DATE ~~R~~ Feb.20/02**V2500-A5/D5 PROPULSION SYSTEMS SERVICE BULLETIN**

This document transmits Revision 2 to Service Bulletin EV2500-72-0241

ENGINE – STAGE 1 TURBINE NOZZLE ASSEMBLY – PROVIDE A NEW STAGE 1 HPT COOLING DUCT ASSEMBLY AND SEGMENTS

Location of the Stage 1 High Pressure Turbine Duct Assembly  
Figure 1

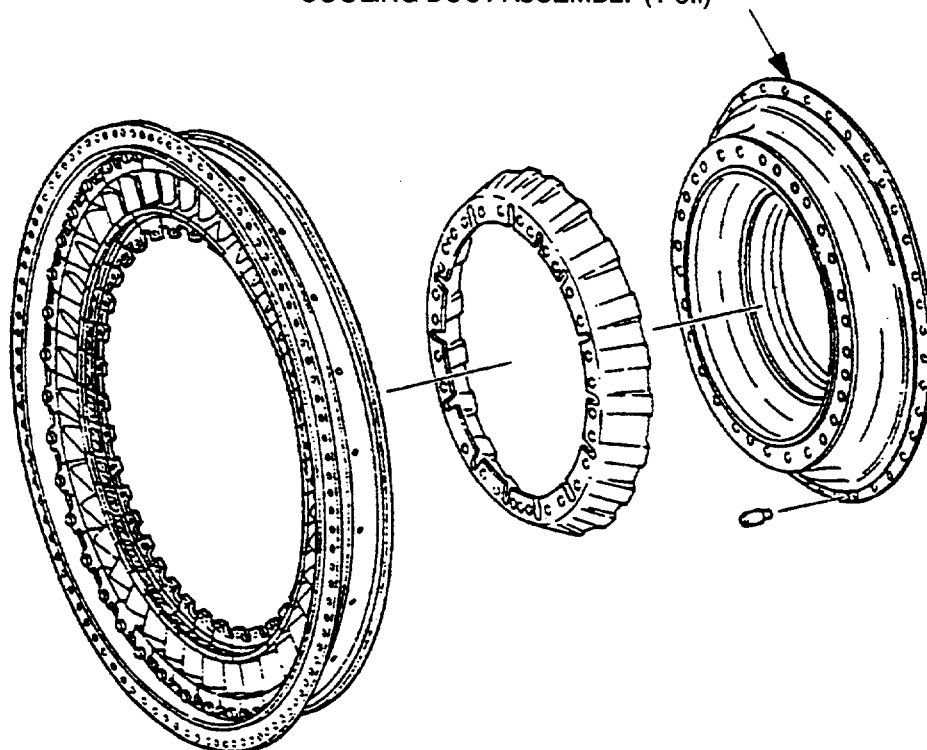
INSTALL THE 2A3180-01 STAGE 1 HPT  
COOLING DUCT ASSEMBLY (1 off)

- (a) Set-up and machine 16 holes 0.213 - 0.223 in. (5,41 - 5,66 mm) diameter. Refer to Figures 1 and 3 (Sheets 1 thru 3)
- (b) Set-up and machine two holes 0.196 - 0.206 in. (4,98 - 5,23 mm) diameter. Refer to Figures 1 and 3 (Sheets 2 and 3).

Location of the Stage 1 High Pressure Turbine Duct Segments  
Figure 2

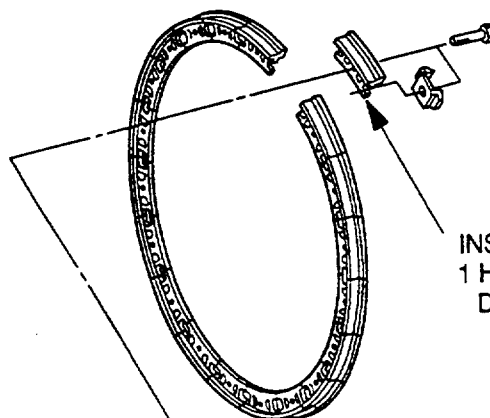
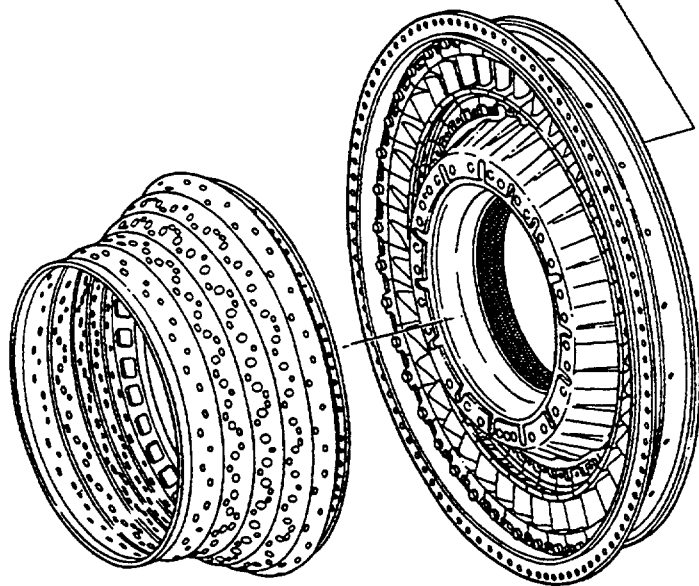
INSTALL THE 2A3181 STAGE  
1 HIGH PRESSURE TURBINE  
DUCT SEGMENTS (20 off)

- (2) Do a modification of the 2A2364 Stage 1 High Pressure Turbine (HPT) Duct Segments (20 off). See Reference (3), 72-44-60 Figure/Item No. 01-010).
- (a) Set-up and machine to open the two 0.079 - 0.083 in. (2,007 - 2,108 mm) to 0.114 - 0.124 in. (2,90 - 3,15 mm) diameter. Refer to Figures 2 and 4. Reference (4).

Modification of the Stage 1 High Pressure Turbine Duct Assembly  
Figure 3 (Sheet 2)

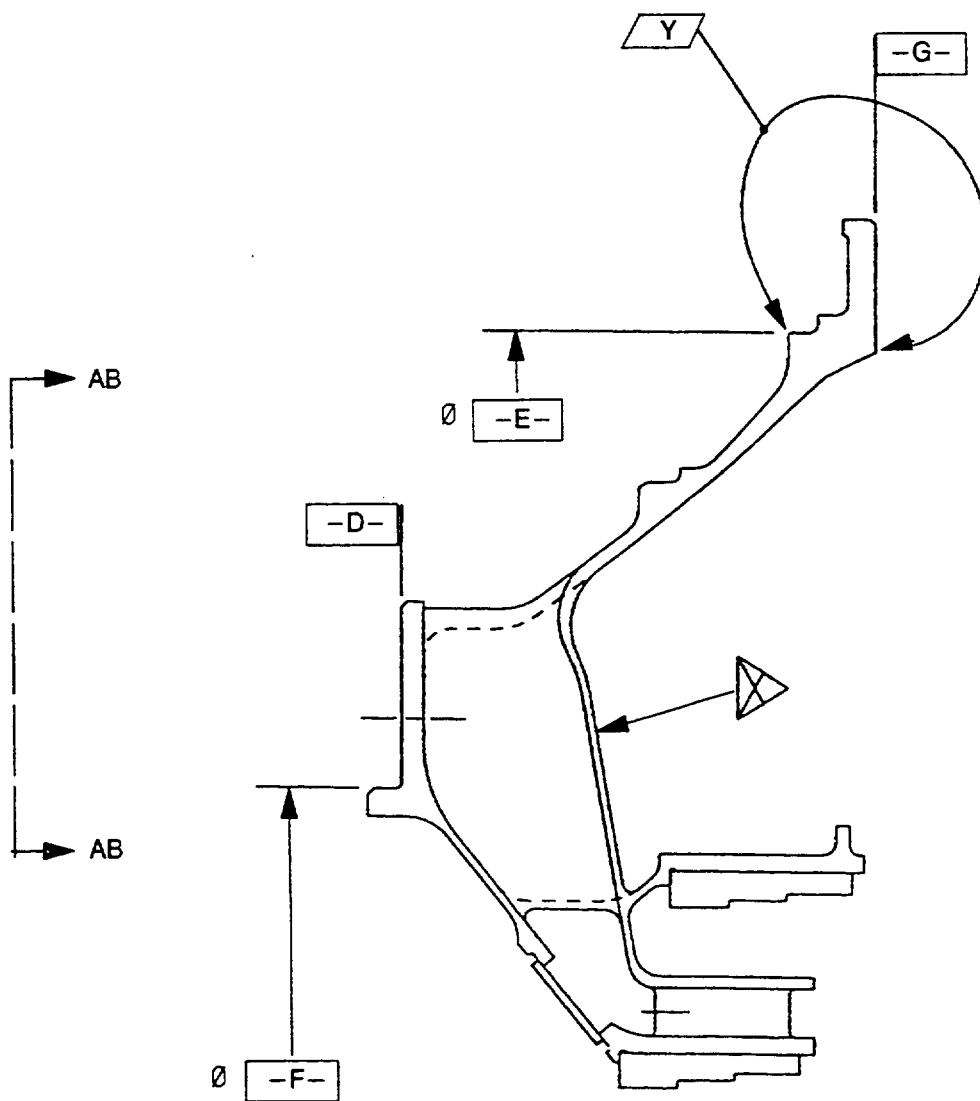
MARK IDENTIFICATION AT THIS LOCATION BY PROCEDURE SPECIFIED IN TEXT

Family Tree - High Pressure Turbine (HPT) Cooling Duct Assembly Ref. Catalog  
Sequence No. 72-44-50. Fig. 01 Item 010  
Figure 6

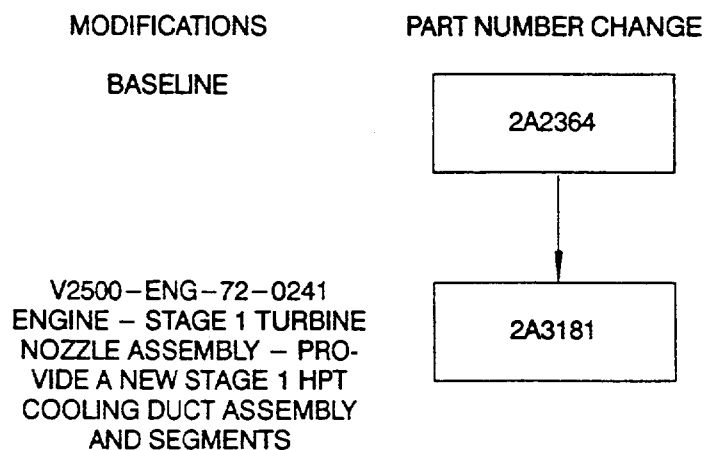
Reason for change  
 To update Effectivity and  
 correct illustration (Fig.6)  
 To update Effectivity and  
 correct illustration (Fig.6)
